## Water Resources Department

September 8, 1999

REQUEST FOR WRITTEN APPROVAL TO USE CONSTRUCTION METHODS NOT INCLUDED IN OREGON ADMINISTRATIVE RULES 690-200 THROUGH 690-240

(7) Diagram showing the pertinent features of the proposed well design and construction (attach additional pages if needed):

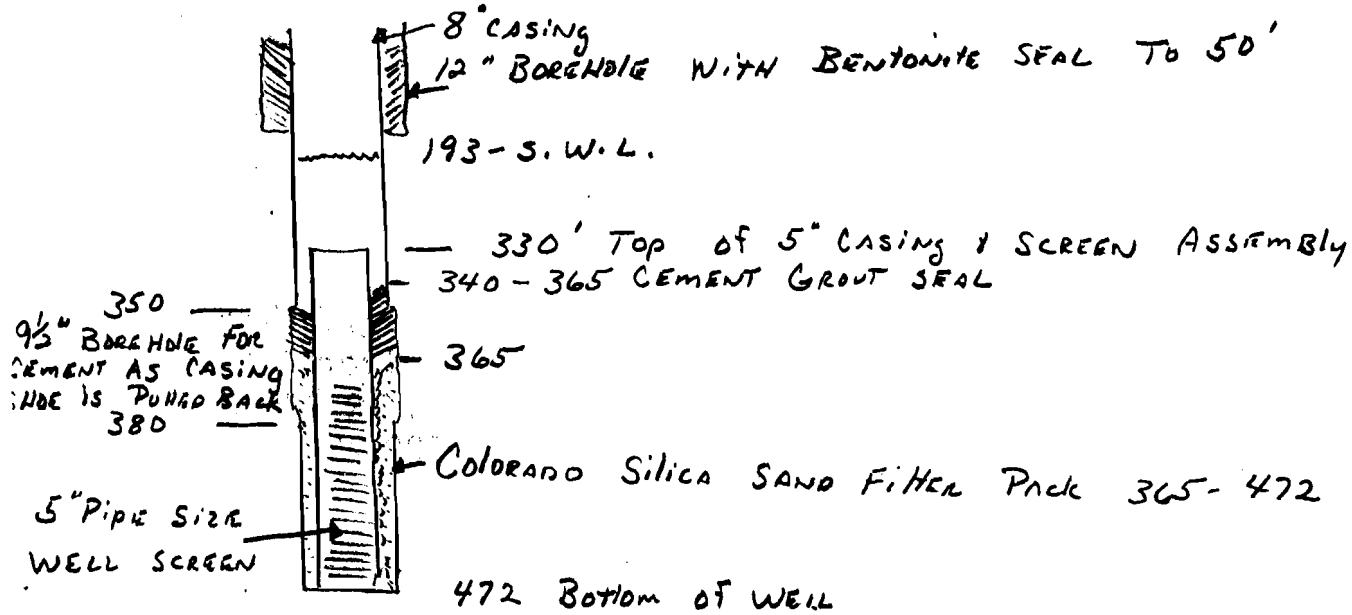
(5) The unusual conditions which necessitate this request: THE NEED TO SEAL

5" CASING IN THE LOWER SECTION OF AN  
8" WELL.

THIS WELL HAS 3 DIFFERENT WATER BEARING ZONES.

#1 FROM 197-212. #2 356-360, #3 390-472. A CEMENT

SEAL WAS PLACED FROM 365 UP TO 340 TO COMPLETELY

ISOLATE EACH WATER BEARING ZONE. THIS SPECIAL  
STANDARDS REQUEST IS FOR THE REDUCED ANNULUS AT 340'-35

Date: 9-8-99

Approved by: [Signature] Denied by: \_\_\_\_\_

- (7) Diagram showing the pertinent features of the proposed well design and construction (attach additional pages if needed):

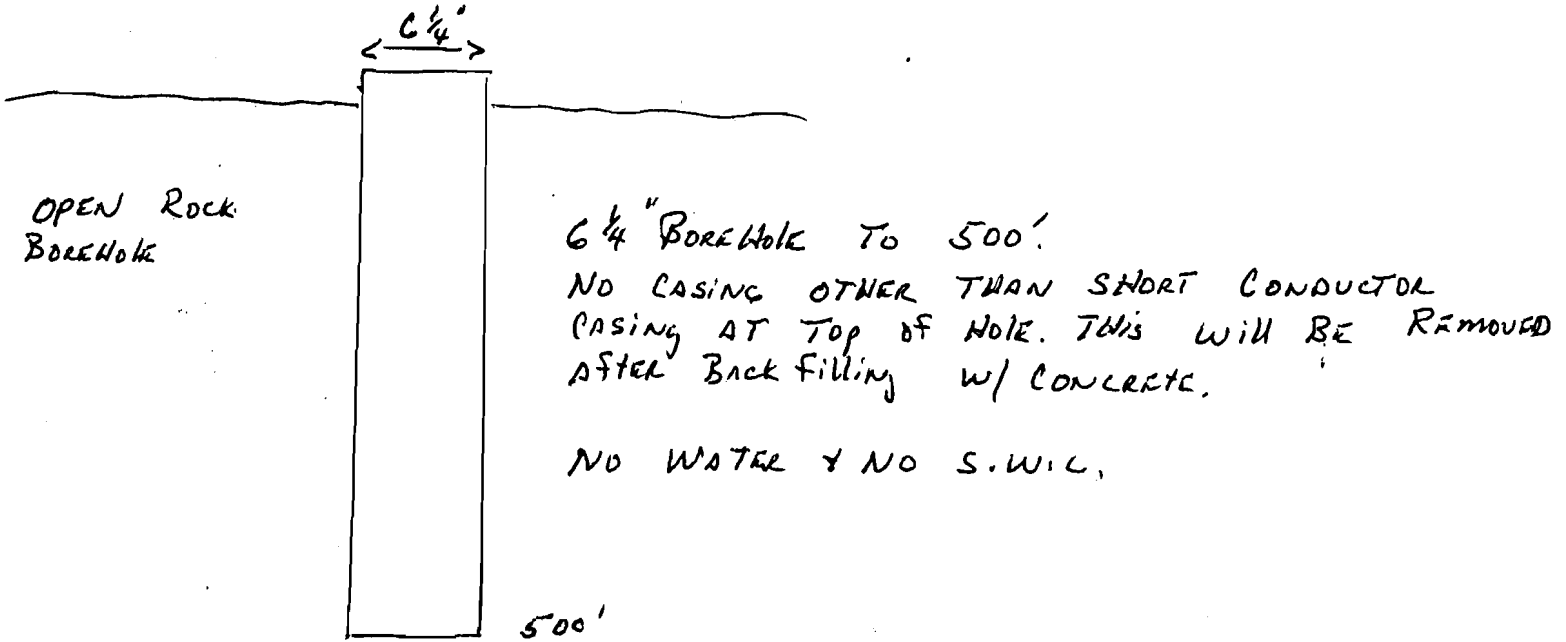
(5) The unusual conditions which necessitate this request: A DRY WELL THAT  
IS 6 1/4" DIAMETER 500' DEEP. WE WOULD LIKE TO  
USE CONCRETE TO FILL THE WELL BORE.

(6) The proposed construction methods that the well constructor believes will be adequate for this well (attach additional pages if needed)  
Slowly Pour Concrete Down The Borehole To  
Completely Back Fill.

Date: 9-8-99

Approved by: [Signature] Denied by: \_\_\_\_\_
